Product Change Notice (PCN)

PCN Number: PCN-0455137R-01

Product(s) Affected: *PJ-059AH*

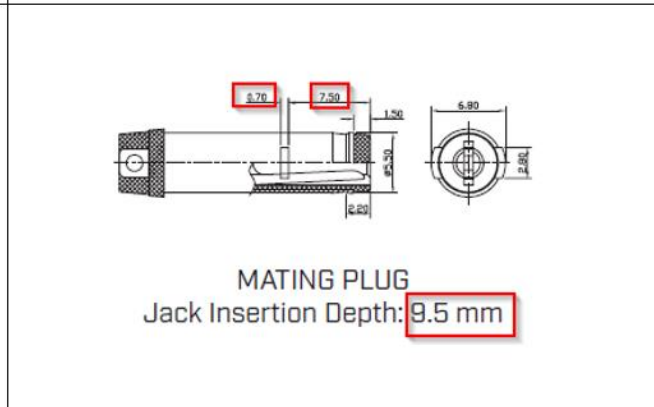
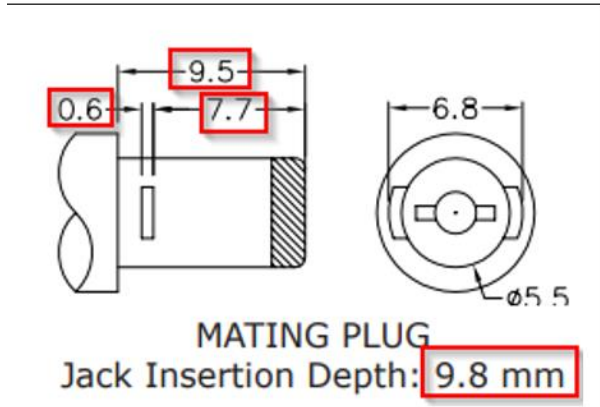
Description of Change: *Minor Housing and footprint differences. Material Change on the housing and terminals. See image Below*

PREVIOUS CUI DEVICES DETAIL / IMAGE			NEW CUI DEVICES DETAIL / IMAGE		
	MATERIAL	PLATING	DESCRIPTION	MATERIAL	PLATING/COLOR
center pin	copper	nickel	center pin	brass	nickel
terminal 1	brass	silver	terminal 1	brass t=0.30	silver
terminal 2	copper alloy	silver	terminal 2	bronze t=0.25	silver
terminal 3	brass	silver	terminal 3	brass t=0.30	silver
plastic	PBT		cover	PBT (UL94V-0)	black
			housing	PBT (UL94V-0)	black
